SPRINGFIELD GREEN OFFICIAL DEVELOPMENT PLAN MODIFICATION NO.3

OFFICIAL DEVELOPMENT PLAN MODIFICATION

INTENT OF MODIFICATION NO.3

SHEET 2 OF 6

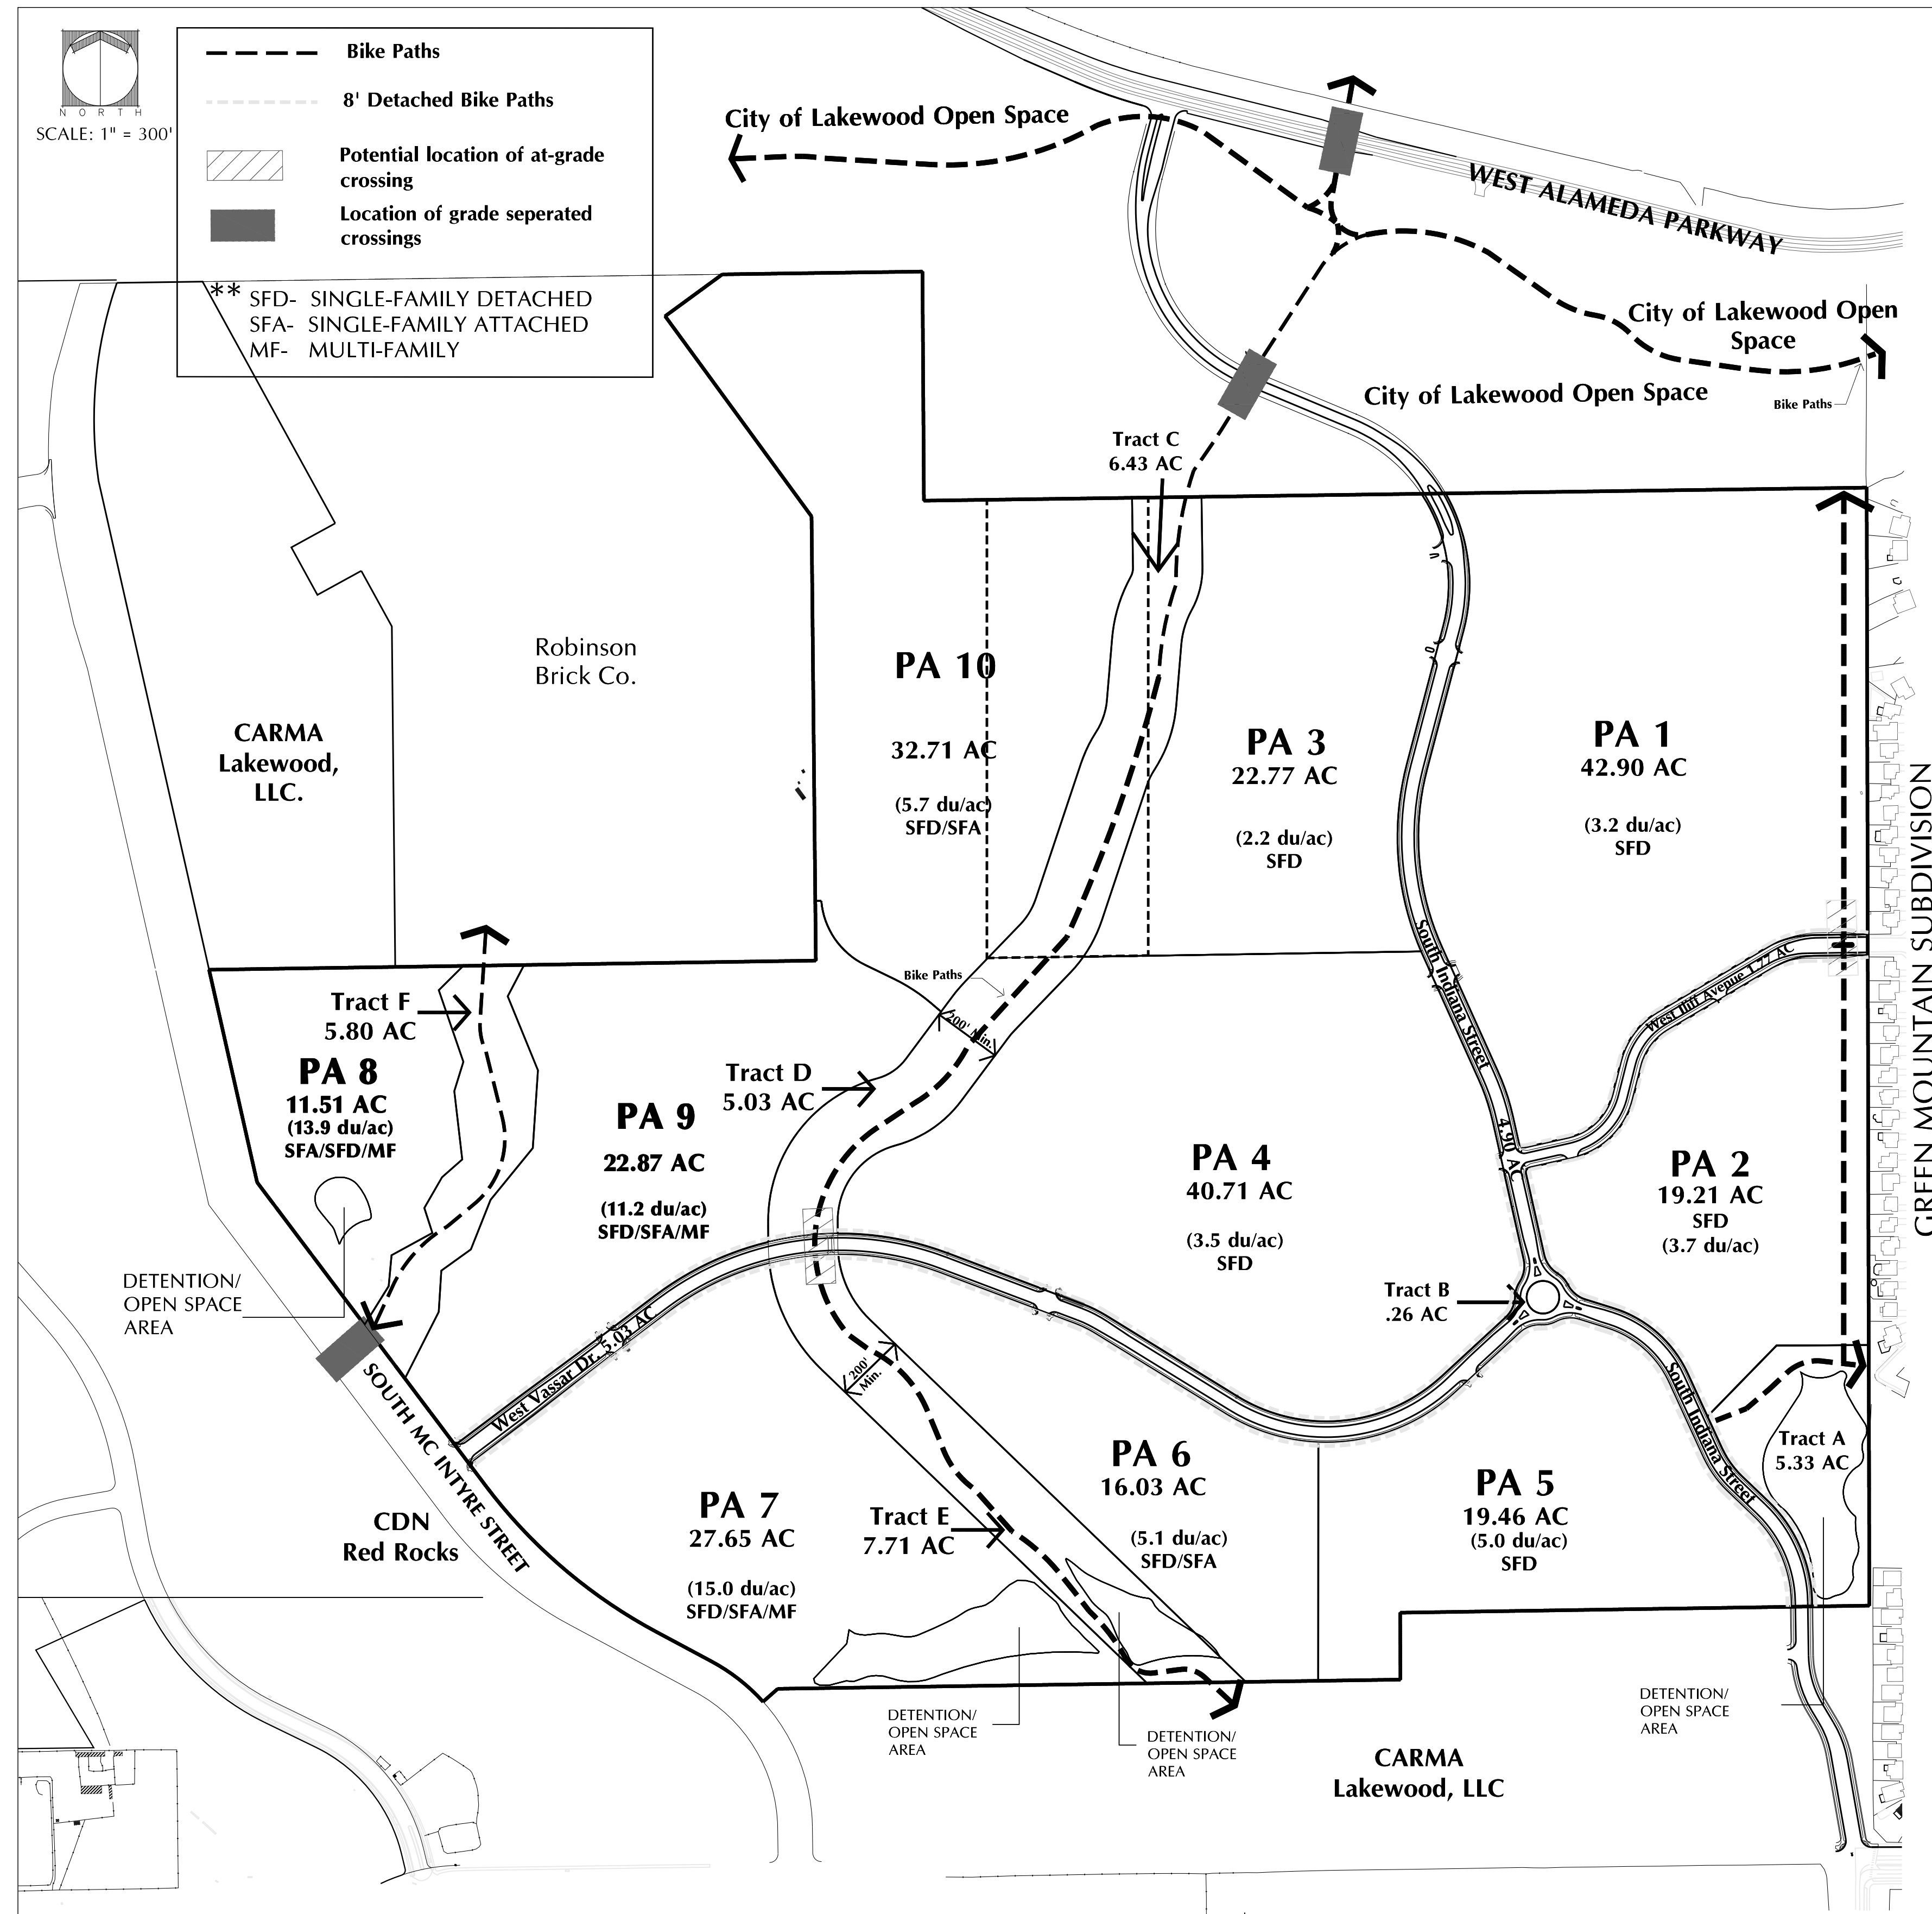
- NOTE 1: This Springfield Green ODP Modification No. 3 makes the following adjustments: PA-1 unit decrease of 27 units, PA-2 unit decrease of 1 unit, PA-3 unit decrease of 46 units, PA-4 unit decrease of 41 units, PA-6 unit decrease of 12, PA-7 unit increase of 138 units, PA-9 unit increase of 104, and PA-10 unit decrease of 115 units.
